# BOROUGH OF OCEANPORT PLANNING BOARD

## REGULAR MEETING • AGENDA

**JANUARY 13, 2026 at 7:00 PM**

**VARIANCE PLAN FOR BUILDING ADDITION**

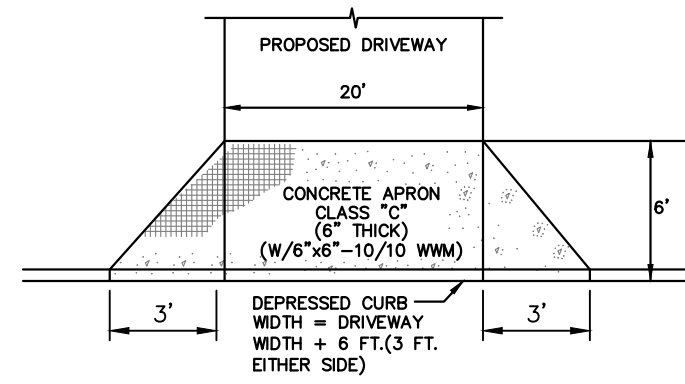
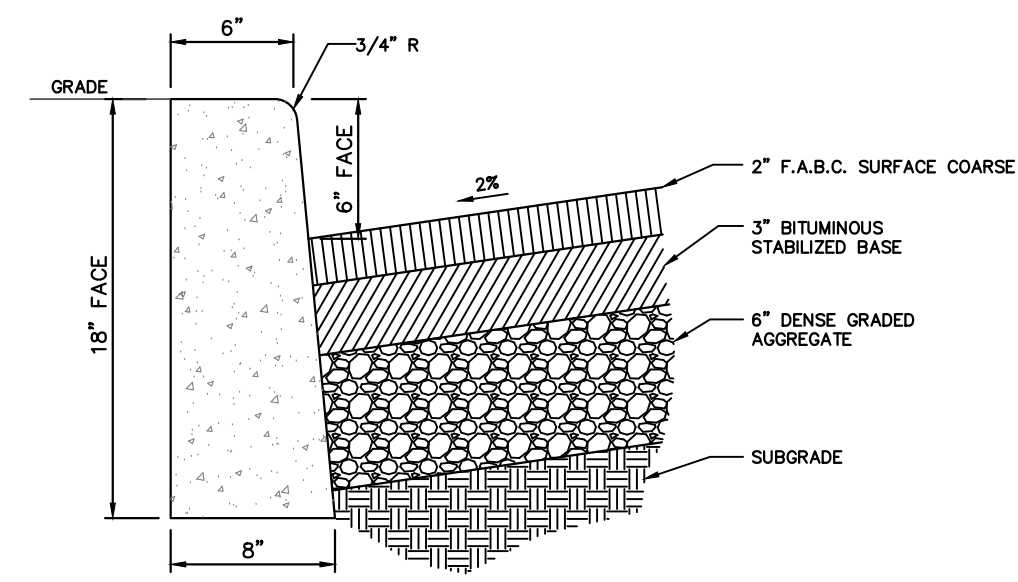
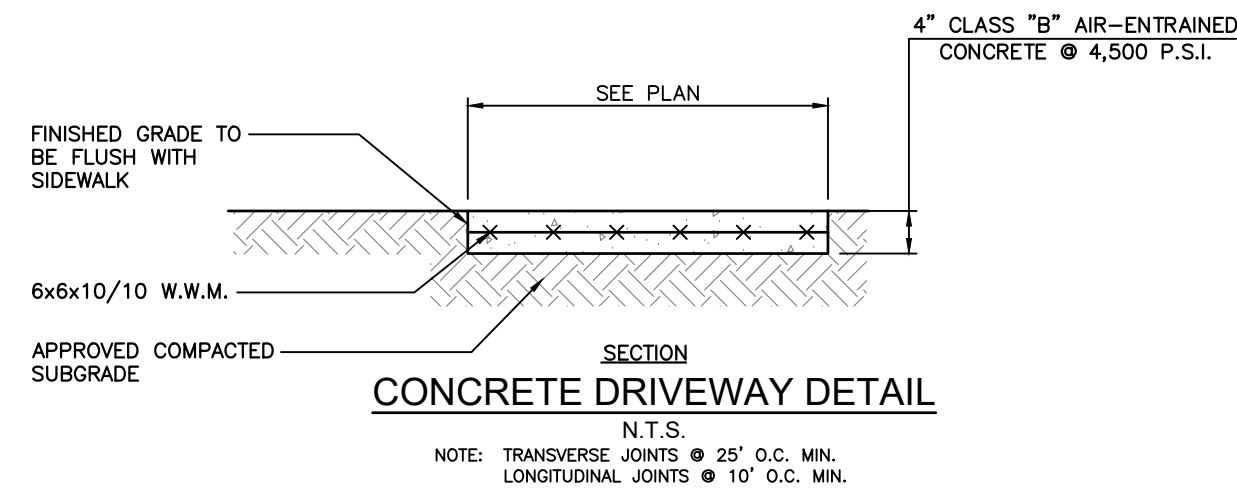
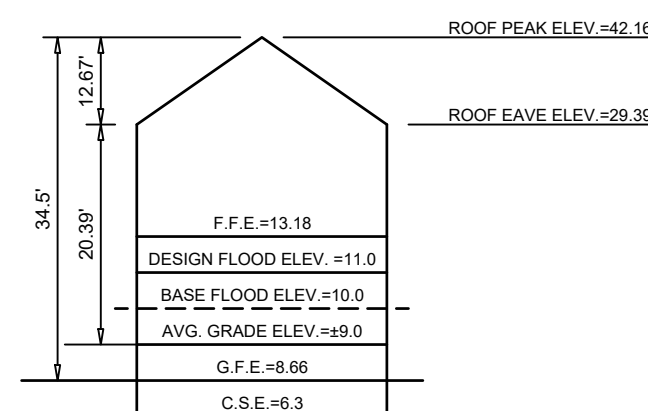
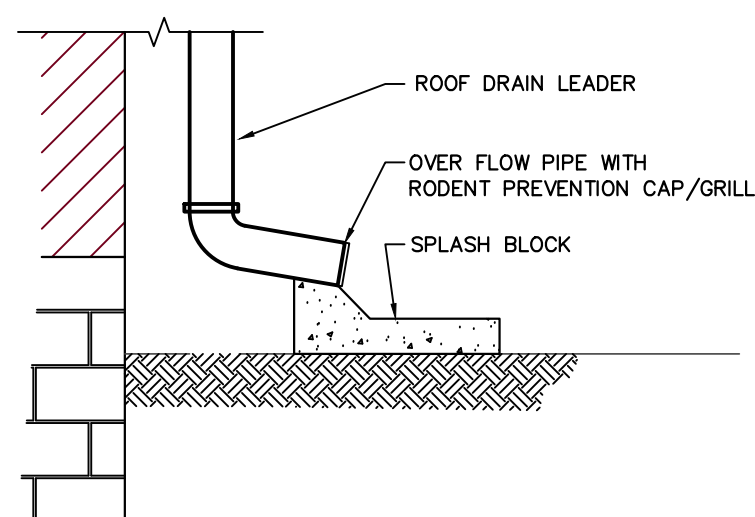
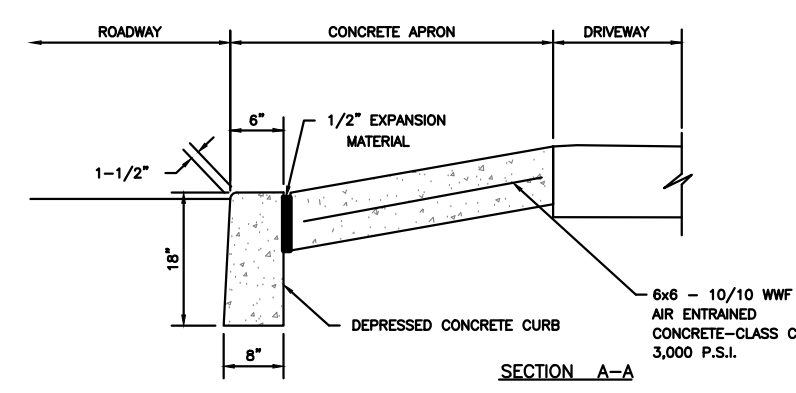
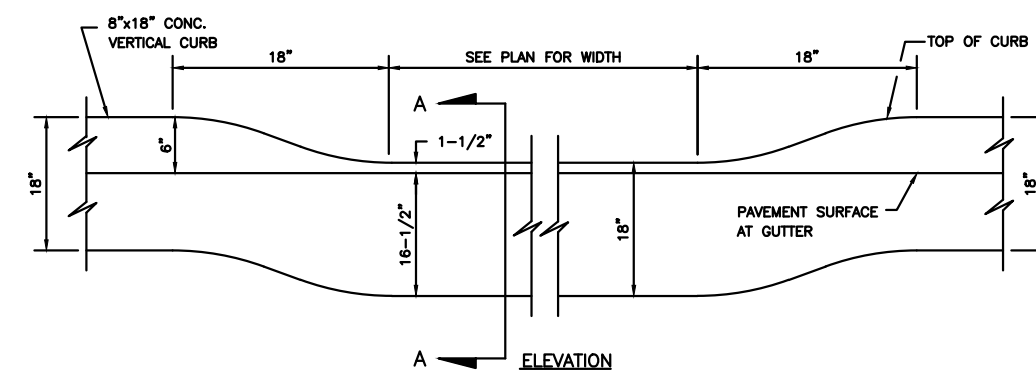
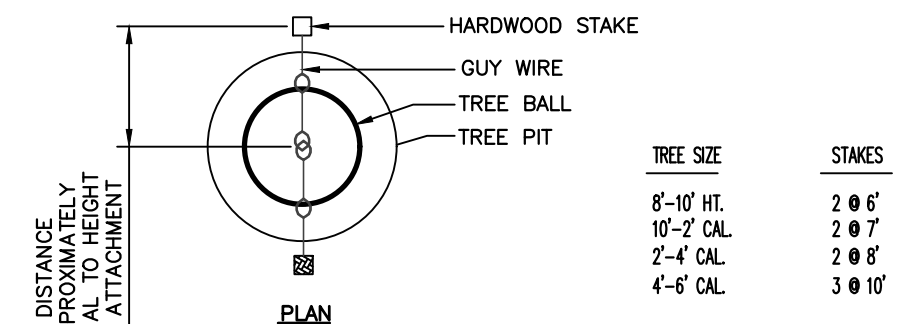
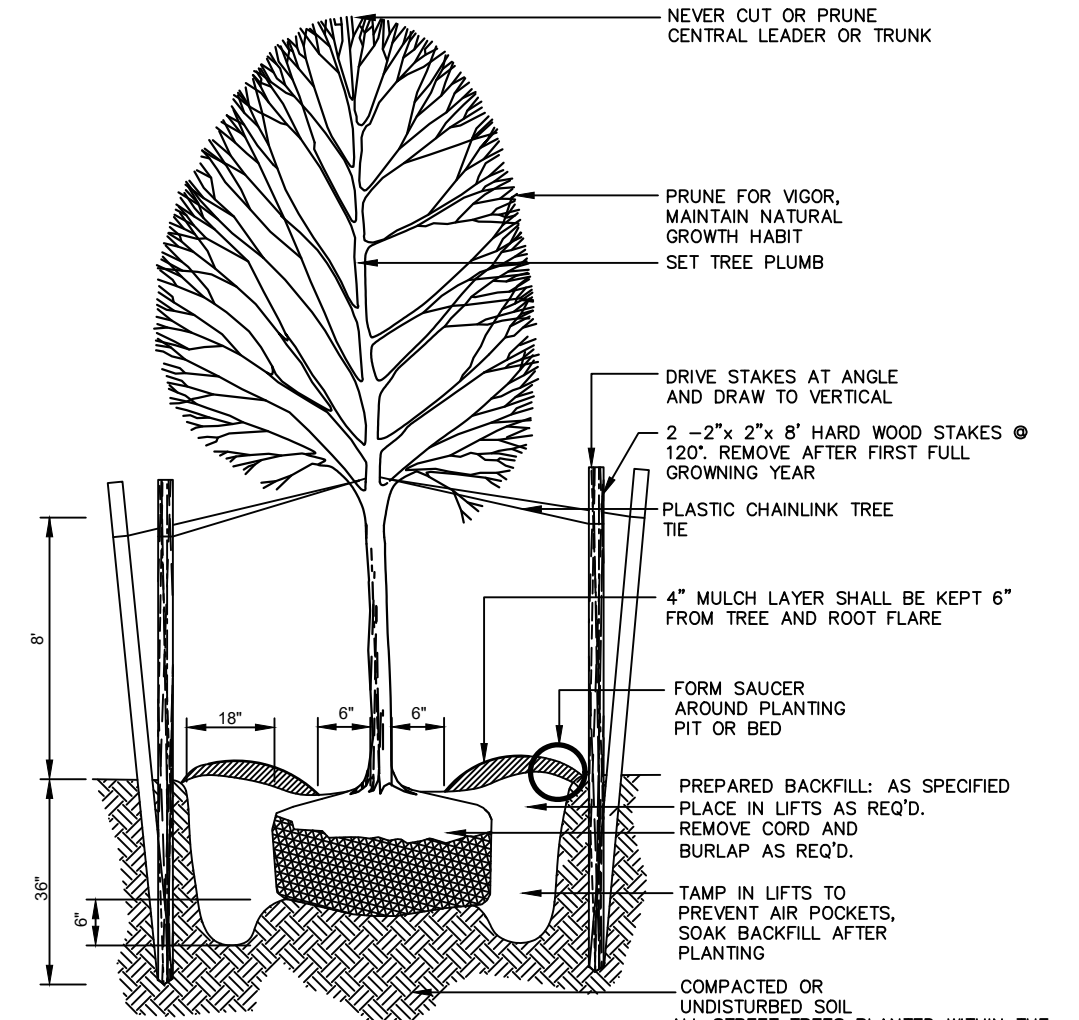
1. The two-bedroom Maid's Quarters has been removed from the design and replaced with a new Game Room.
2. The rear entrance and walkway to the Maid's Quarters have been removed from the design.

3. The existing shed is proposed to be removed to eliminate the existing non-conformity of the side yard setback for an accessory building.
4. The impervious coverage calculations have been revised in accordance with the plan changes such that there is no increase in impervious coverage between the existing and proposed conditions.

5. A calculation of average principal building setback from mean high waterline within 200 feet of each side of the property on the same block has been added to the plan.

6. The existing retaining wall to be modified has been altered to reduce the increase in height proposed and will be no greater than 3 feet in height.
7. Street trees have been added to the plan in compliance with the township ordinance.

8. A detail demonstrating the base flood elevation relative to the floor elevations of the structure has been added to the plan.
9. The existing and proposed roof leaders have been added to the plan.

10. A construction detail for the proposed concrete driveway apron has been added to the plan.
11. A construction detail for the proposed concrete driveway has been added to the plan.

12. A construction detail for the concrete curb/pavement section repair in the Borough right-of-way has been added to the plan.
13. A detail for the proposed street tree planting has been added to the plan.

**Application No. PB2025-17**

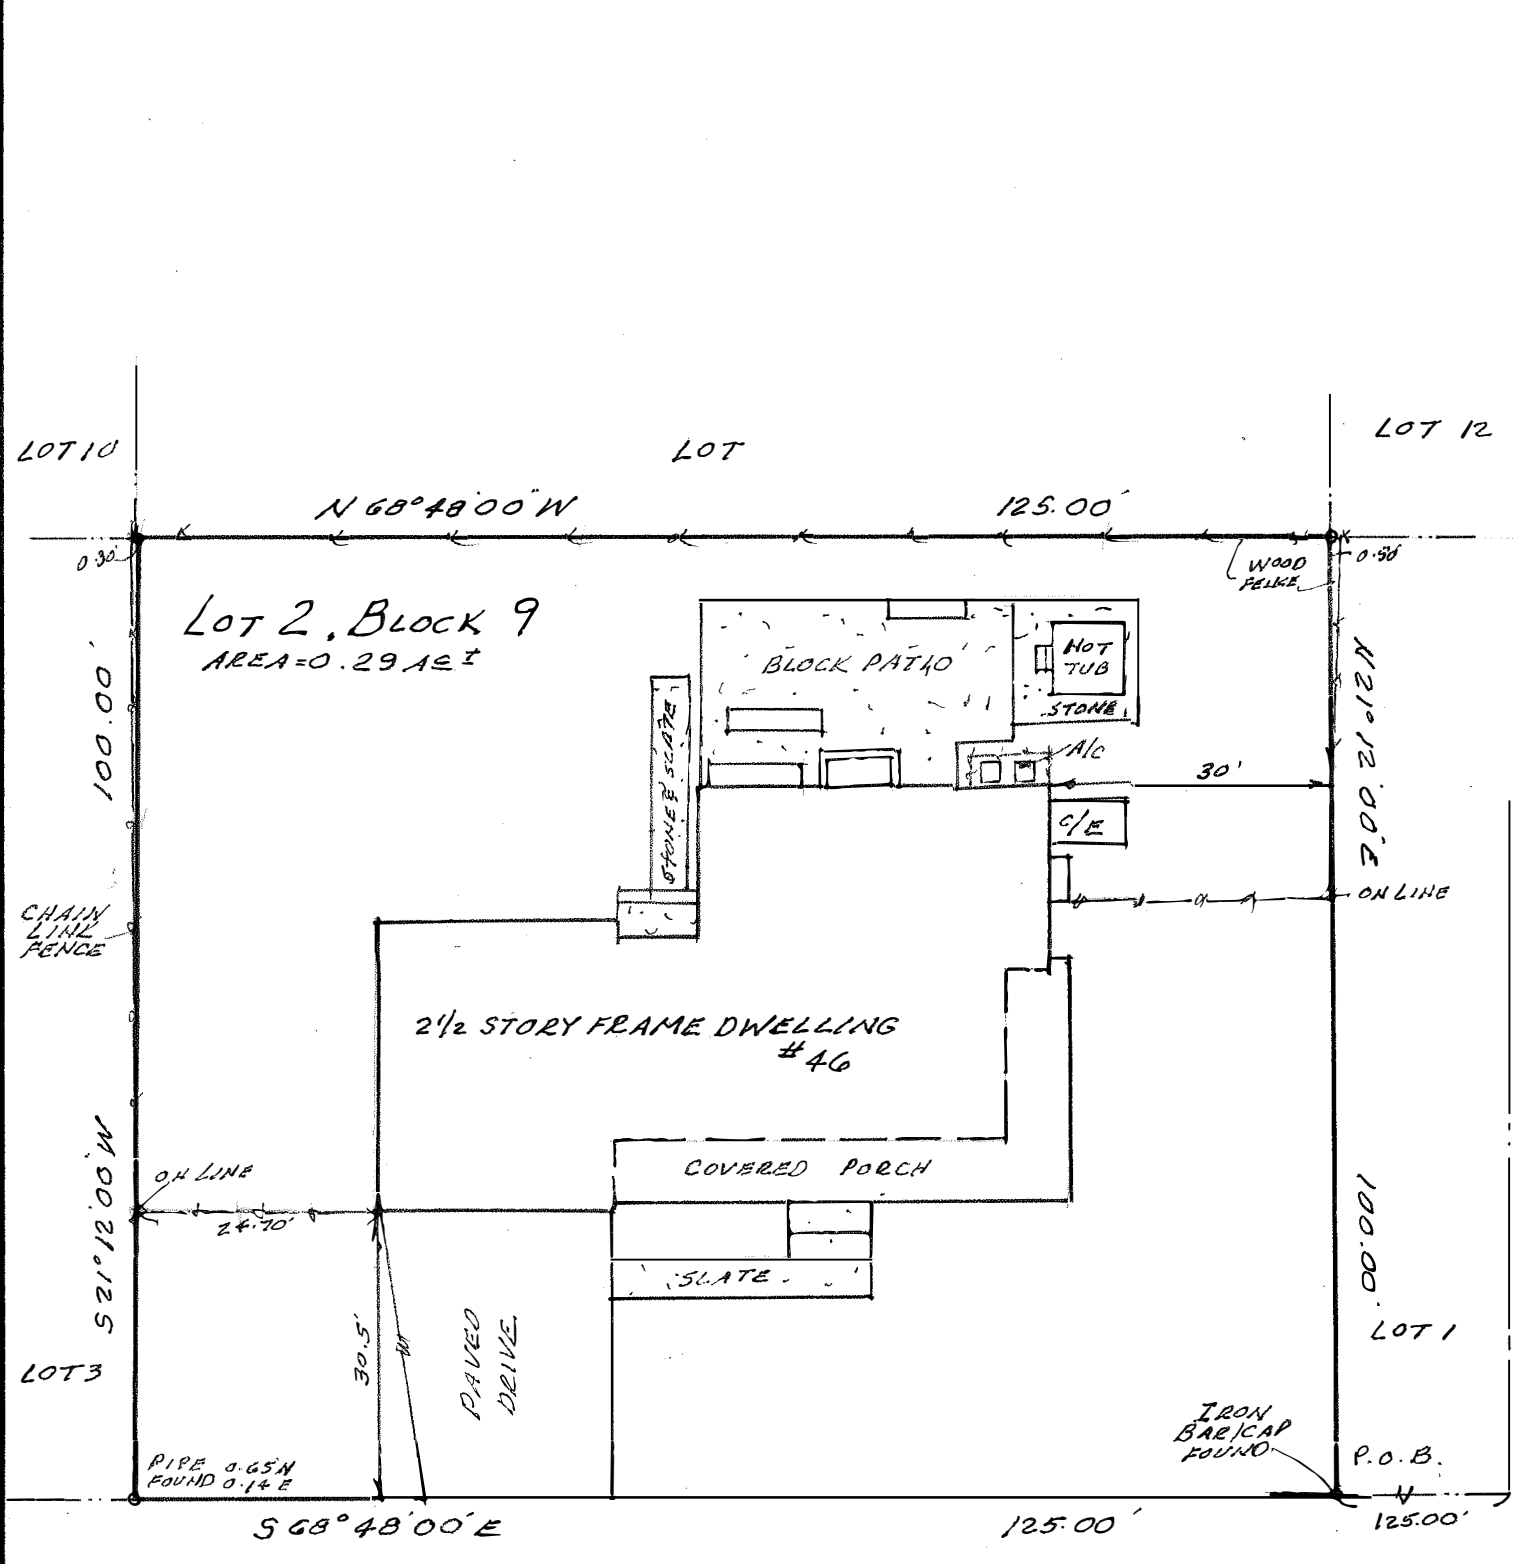
- a) Maximum Impervious Coverage – 37% permitted, 35.8% existing, 47.2% proposed. The applicant should discuss what measures are being provided to mitigate the additional runoff flowing over the rear property line.

1. A signed and sealed copy of the boundary and topographic surveys shall be submitted.
2. The swale slope in the eastern side yard only provides a 0.8% slope whereas a minimum of 1% is required. A series of inlets and pipes should be used to collect the runoff between the pool and rear property line and pipe it out to the front yard. Additional topography information of the side yard will be needed to properly design the system.
3. Testimony shall be provided as to the ownership of the various fences enclosing the pool. A detail of the fence should be submitted to the Board at or before the hearing.
4. The property is **not** located in a flood zone.
